## Idaho Department of Environmental Quality Point of Compliance Determination

**Project Name:** Proposed Blackfoot Bridge Mine, Caribou County, Idaho

**Applicant:** P4 Production, L.L.C.

Proposed POC Locations  
Blackfoot Bridge Project  
Caribou County, Idaho  
FIGURE 19

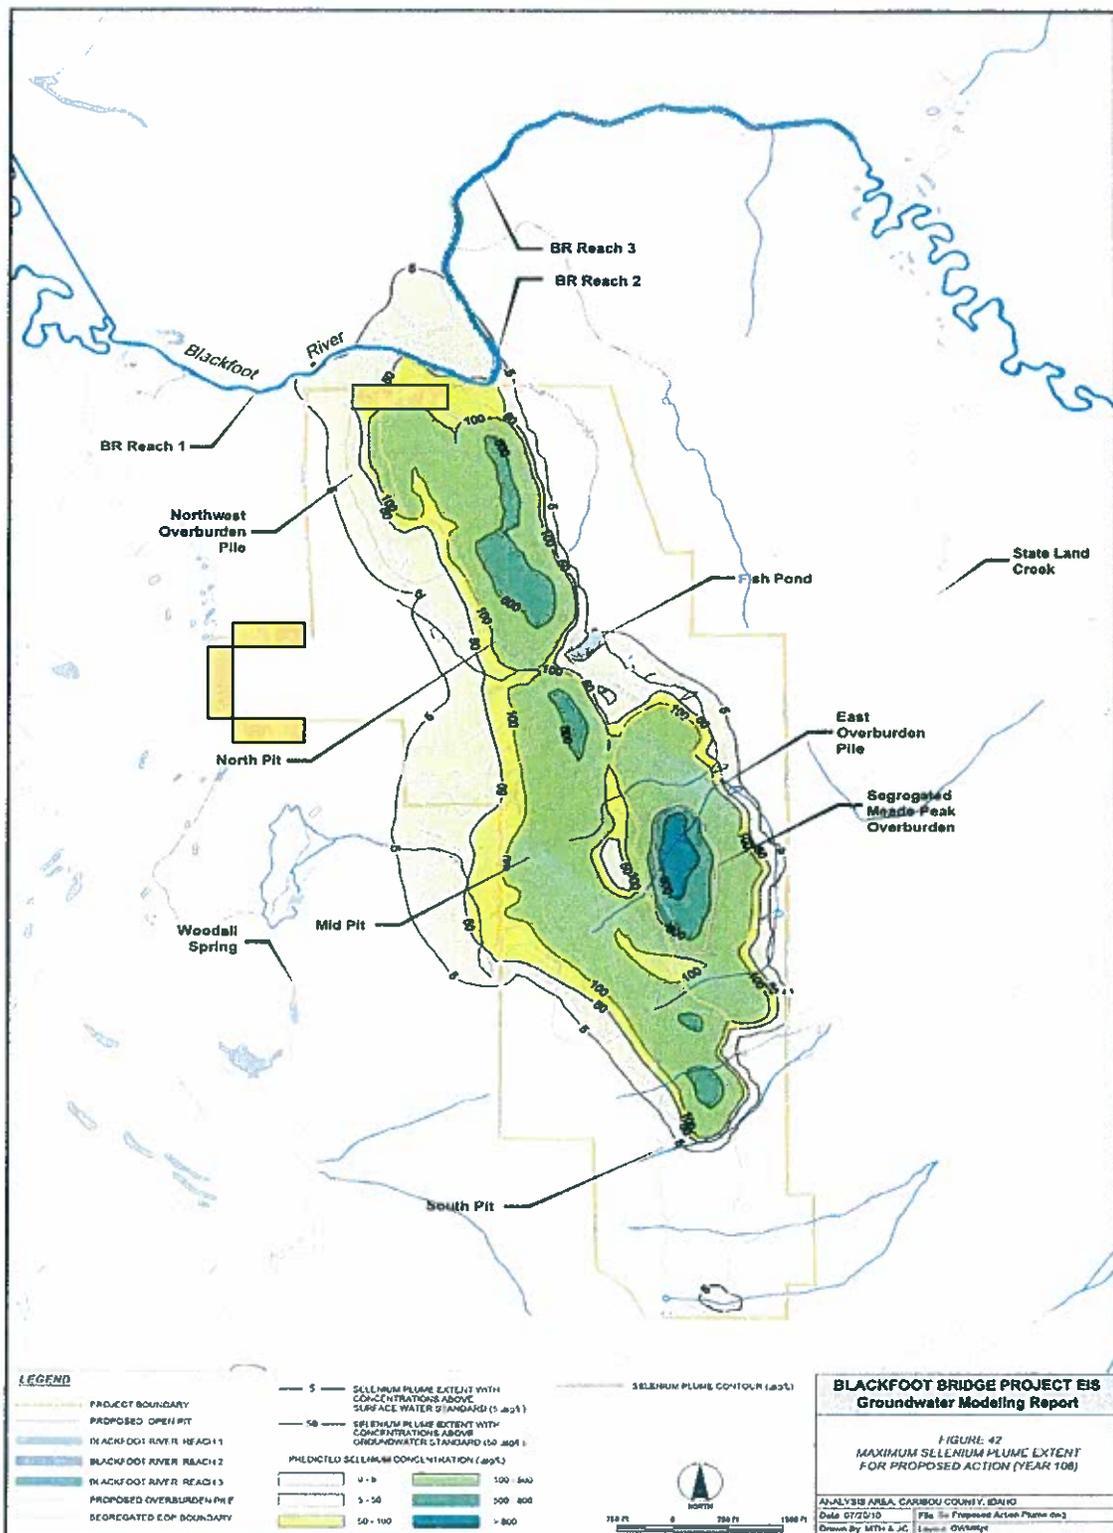
The proposed compliance points are inadequate north of the North Pit between MW-17W and MW-14W (see Figure 19 for proposed monitoring well locations from the POC application). Therefore, at least three additional monitoring wells (points of compliance) are needed in the Wells Formation at locations distributed between the existing wells MW-17W and MW-14W, but skewed eastward toward MW-17W to coincide with the modeled selenium plume geometry. Figure 42 (modified from *FINAL Groundwater Modeling Report Blackfoot Bridge Project, July 2010*) identifies this additional area of concern between the north end of the mine and the Blackfoot River. The base map for the figure is the maximum plume extent modeled for the "Proposed Action" as described in the Draft EIS and Final EIS. This figure was selected to represent the area of additional concern because mining of the North Pit and the building of the Northwest Overburden Pile will occur over several years and mine reclamation and final cover placement under Alternative 1A (the selected alternative) cannot occur instantaneously after the cessation of mining or overburden placement in this area of the mine. Figure 42 (modified from *FINAL Groundwater Modeling Report Blackfoot Bridge Project, July 2010*) presents

DEQ also determined that at least three additional points of compliance monitoring wells are required in the Wells Formation between MW-17W and MW-14W.

**Comment:** For the reasons stated in the request, P4 believes that monitoring wells MW- 17W and MW-14W are sufficient to detect any contaminants of potential concern migrating northward from the north pit. DEQ's apparent concern over the plume contours depicted on Figure 42 from the Final Groundwater Modeling Report is misguided as that figure is based on the proposed action after 108 years. As DEQ is aware, P4 is not proceeding with the proposed action, but is instead completing Alternative 1A.

Although P4 disagrees with DEQ's determination that additional points of compliance monitoring wells are required between MW-17W and MW-14W, DEQ's concerns could be addressed through the installation of one additional well, just east of the center between the two existing wells. This additional well, operating in conjunction with the existing wells, would allow for detection of any contaminants of potential concern well before there was any concern over potential impact to the Blackfoot River. The proposed construction and location of the additional well would be approved prior to drilling.

**Response:** The north end of the North Pit of the Blackfoot Bridge Project is the most sensitive area of the proposed mine because of the proximity of the North Pit to the Blackfoot River and the fact that ground water in the Wells Formation naturally discharges to the river within 650 feet of mine. The spatial position of the plume contours was used to indicate the probable ground water flow path that will occur from the North Pit area to the Blackfoot River which lies between the existing monitoring wells. The model output used to assess the spatial position of the probable ground water flow path is not from the selected Alternative 1A; the most conservative alternative was used to compare the probable ground water flow path to the locations of the existing monitoring wells to assess their adequacy as points of compliance. The occurrence of several discreet spring discharges from the Wells Formation to the Blackfoot River at the north end of the mine are the rationale for assuming the existence of preferential ground water flow paths which occur at a scale that is impractical to model. The spatial distribution of the proposed and existing monitoring wells is believed to be adequate to detect movement of contaminated ground water before that water can impact the river. Data from other southeast Idaho phosphate mining

locations indicate that the flow paths can be quite narrow within the same hydrostratigraphic unit and concentrations can change by an order of magnitude within 200 feet, even though the source(s) of selenium is 0.6 to 2.5 miles from the monitoring locations. Therefore, more than one additional monitoring well is needed between the existing monitoring wells MW-14W and MW-17W; these wells are separated by over 1,500 feet and the north end of the North Pit is less than 650 feet from the south bank of the Blackfoot River. The modeling cannot exactly replicate the mining on a temporal scale and there will be time frames when the waste rock cannot be covered immediately. Consequently, the proposed monitoring well network is necessary to adequately protect the river. Because ground water flow toward the river will only occur when the hydraulic gradient is not reversed by pit dewatering, the monitoring schedule is linked to the relationship between the river stage and ground water elevations.
